PROJECT NUMBER: SP2024-037
PROJECT NAME: Amended Site Plan for 5901 Horizon Road
SITE ADDRESS/LOCATIONS: 5901 HORIZON RD

SUBJECT: SP2024-037; *Administrative Site Plan for Garages of America*

NOTE: ALL LISTED HEIGHTS ARE ESTABLISHED FROM FINISH FLOOR 0'-0"

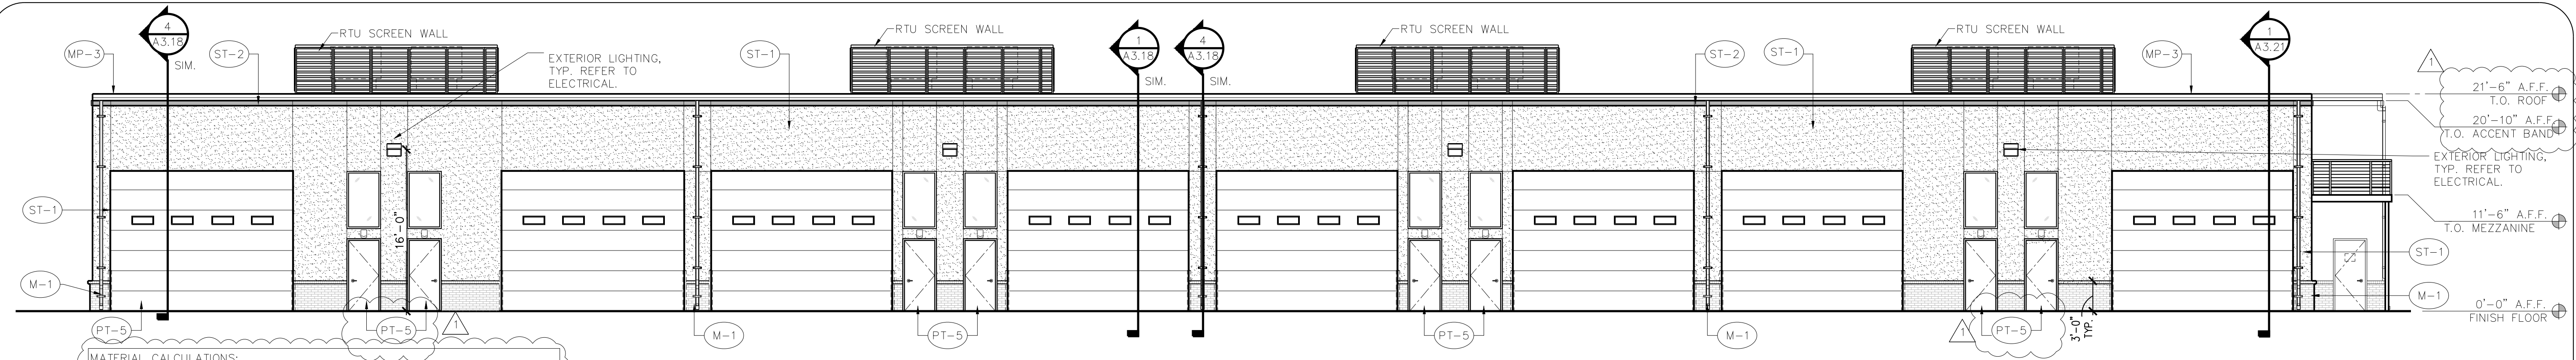
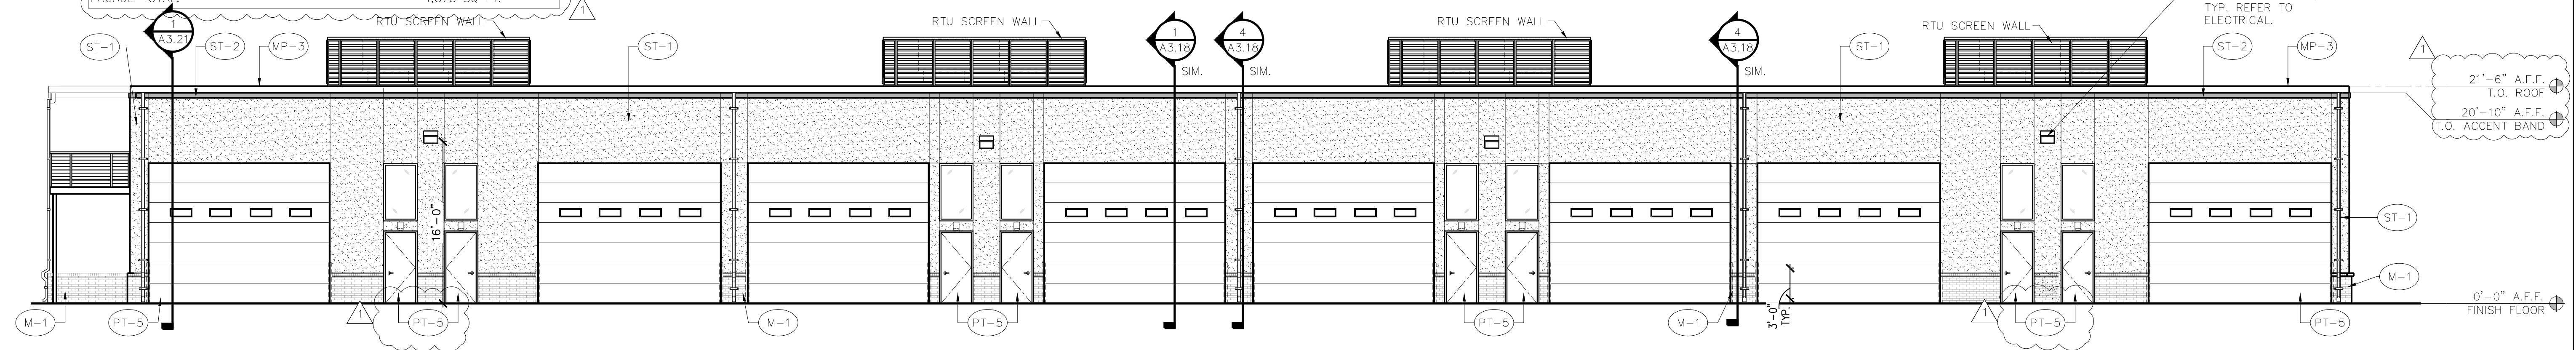
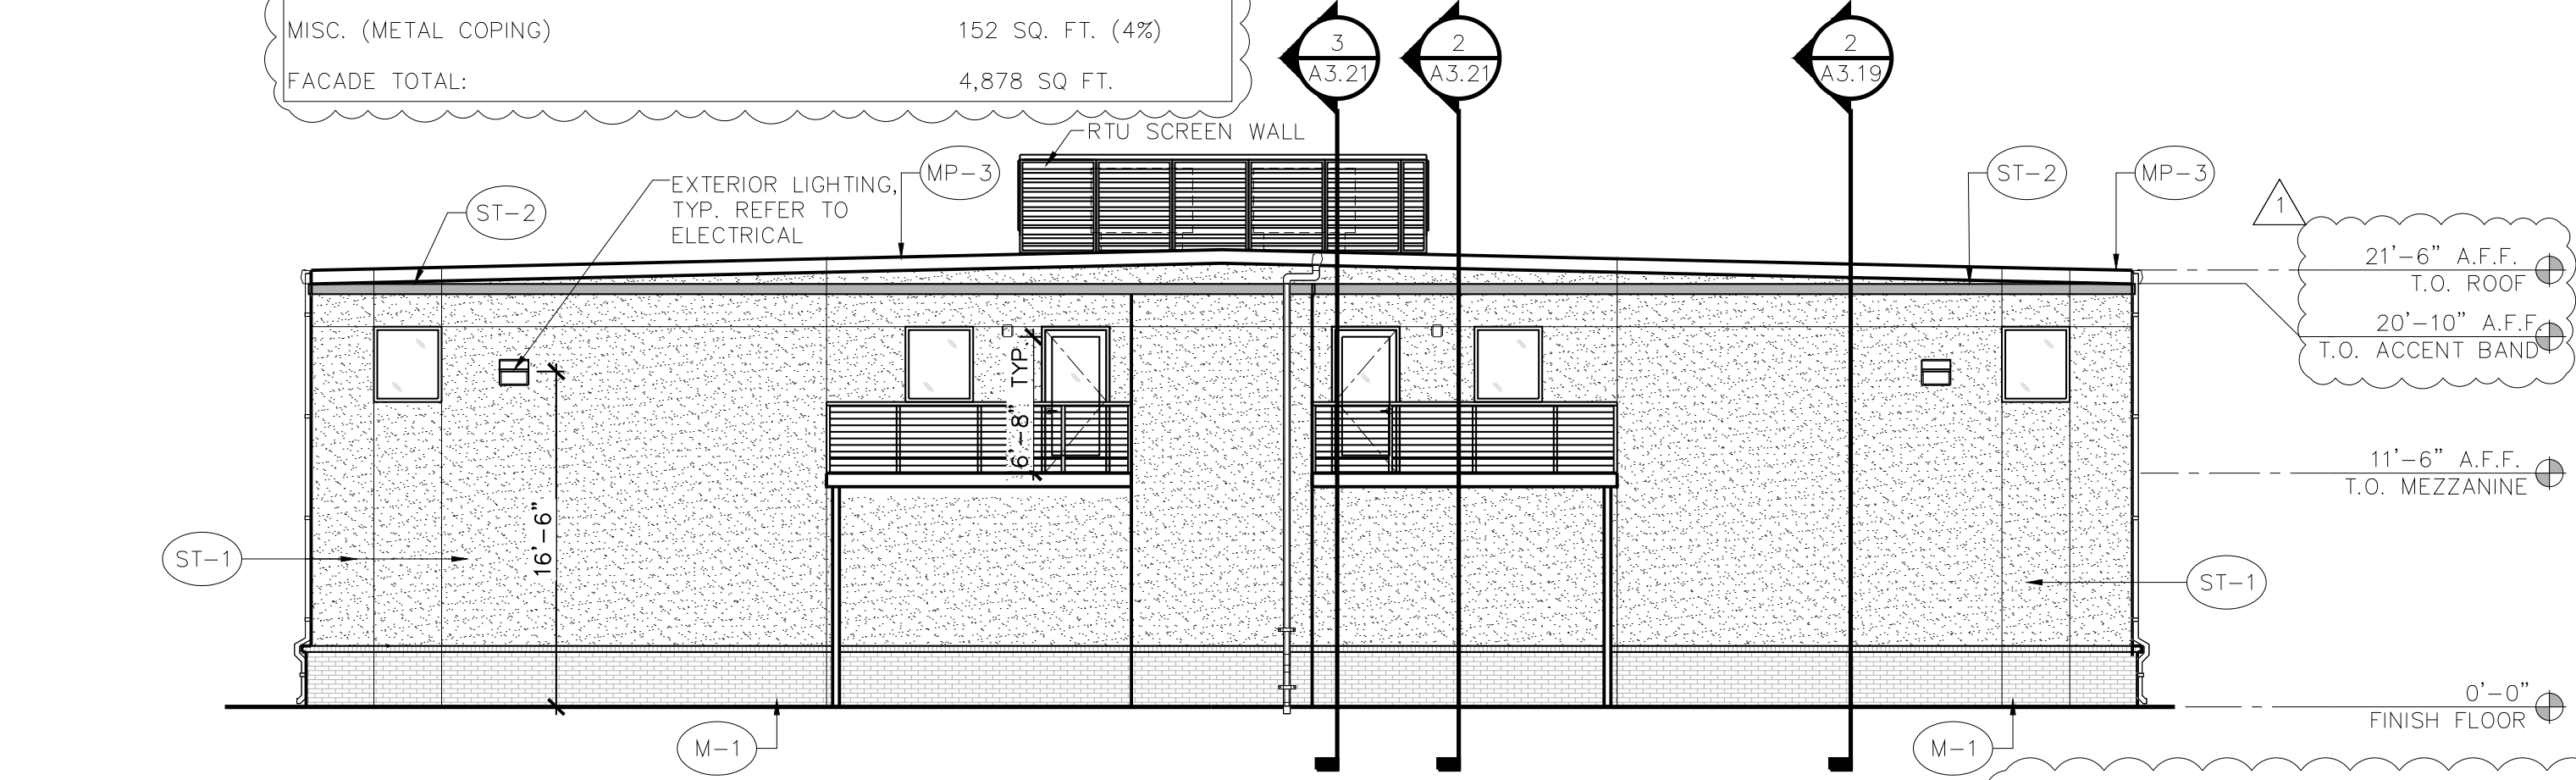
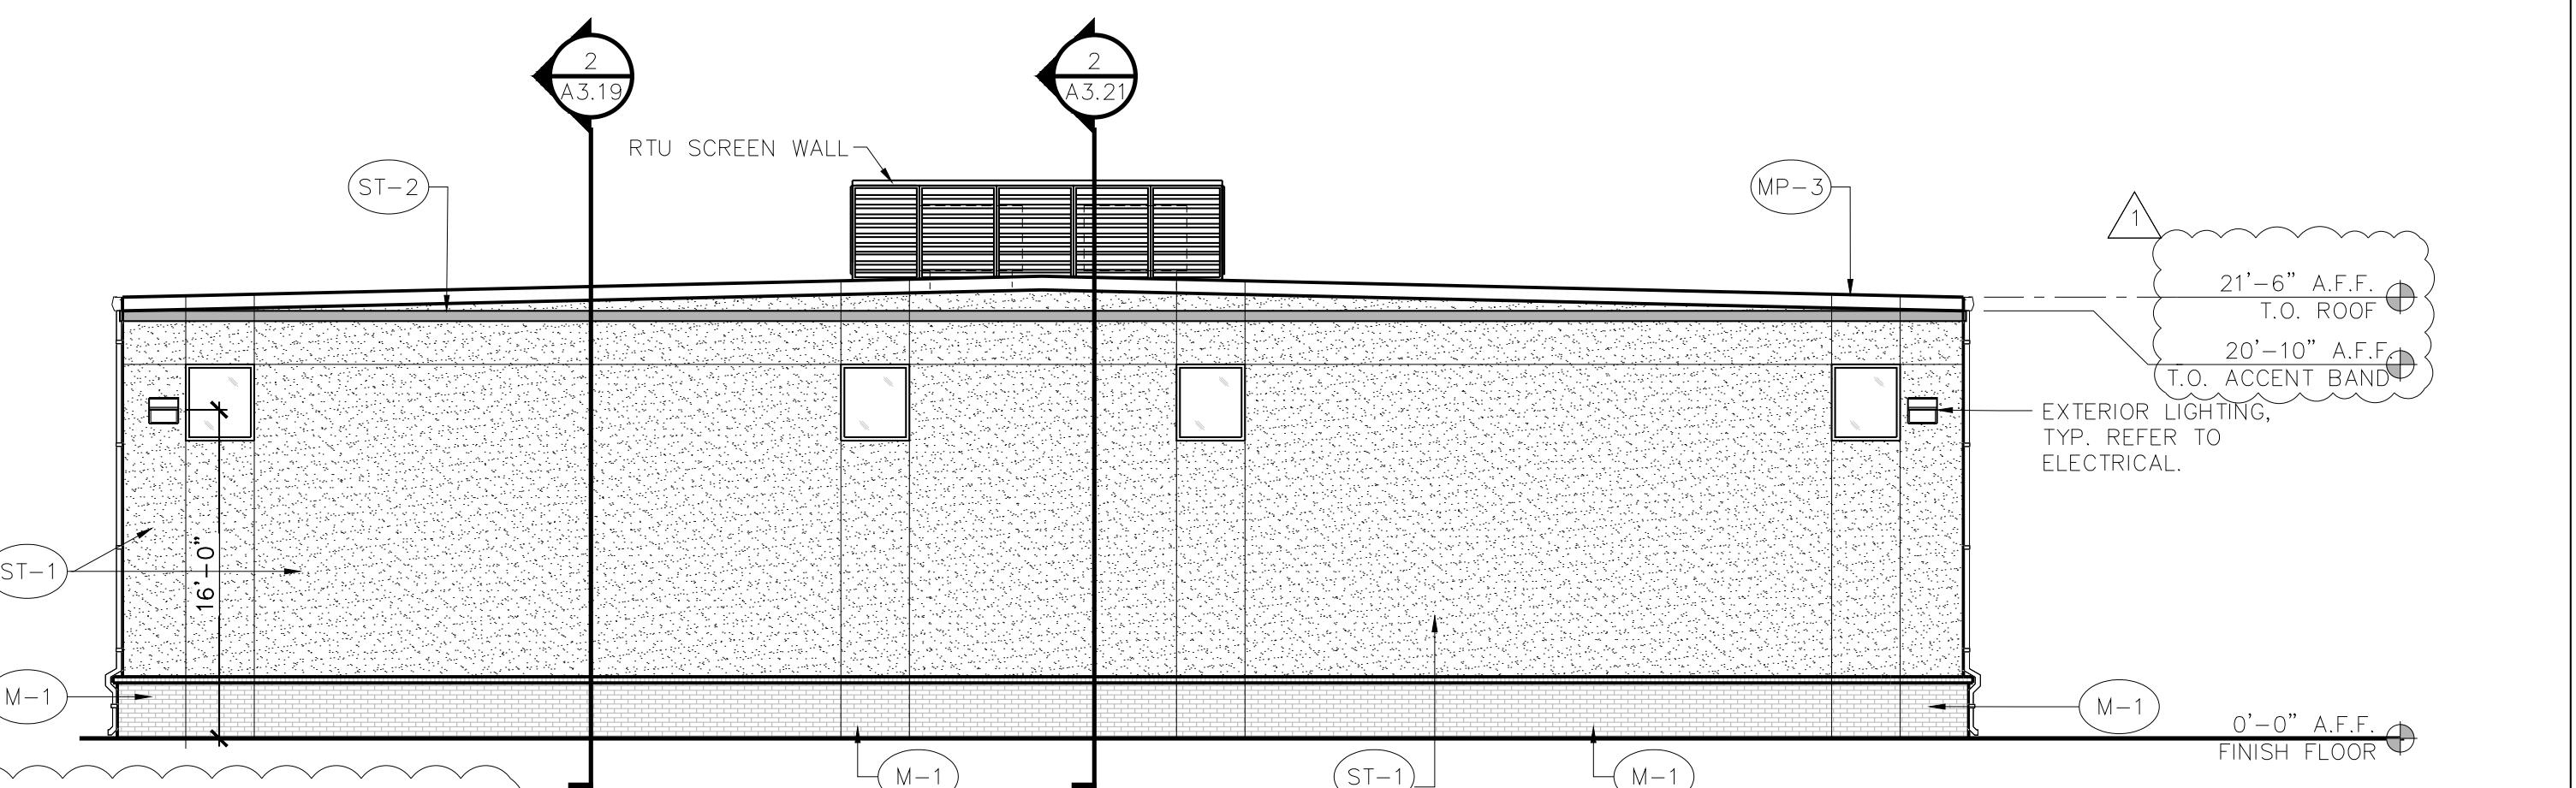
- (1) Please provide Building 1 with the Phase 1 building elevations; Building B was included twice. (Subsection 06.02, of Article 05)
- (2) Please remove the doors and windows from the material percentages. Staff needs to verify that the material requirements are still met. (Subsection 04.01, of Article 05)
- (3) Please indicate the roofing material on the pitched roof buildings. If metal, they must be standing seam; include this on the material table for each building. (Subsection 04.01, of Article 05)
